Bert Meunier Common and Max Crescent Park Engagement Summary

On March 4, 2021, a virtual public information session was held via a zoom webinar to present the proposed plans for Bert Meunier Common and Max Crescent Park. The Concept plans were displayed on large format signs that were placed in each park as well as being posted online on Get Involved Kingston.

Bert Meunier Common - Open Space Option 2.

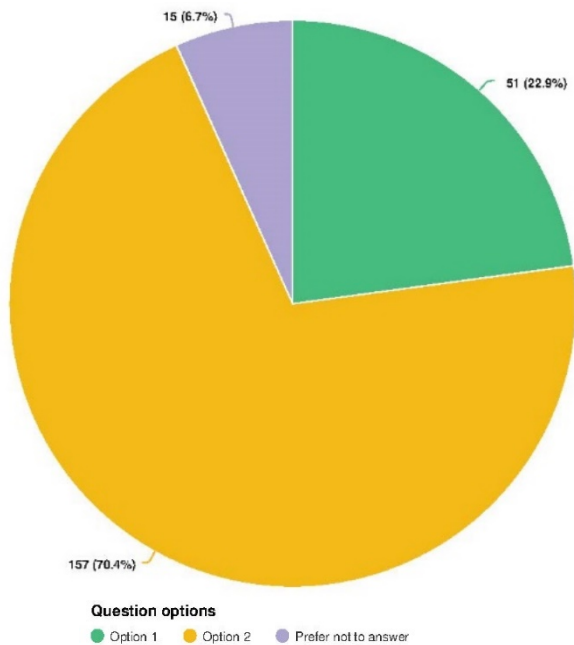
- Open Space Concept #2 was preferred by the majority of respondents and this will be reflected in the final design, which will include a large, elliptical play lawn that can be used for various recreational activities. Goal posts will be considered.

- One respondent commented on its winter use:

For the past 3-4 winters, I have taken good advantage of the present open field to cross-country ski on... it meets the needs of anyone who is interested in getting this type of winter outdoor exercise
- Placing benches and shade trees along the proposed path was well-supported as were the naturalization plantings that are proposed for the park's perimeter and these elements will be retained in the final design.
- A few commented that they would like the park path to be looped. A looped pathway is not proposed due to both spatial and budget constraints. The feedback we received indicated that having a large play field is a priority. As the existing swale at the south edge of the park is to be retained, there is not enough space remaining to accommodate a southern leg of pathway to close the loop.
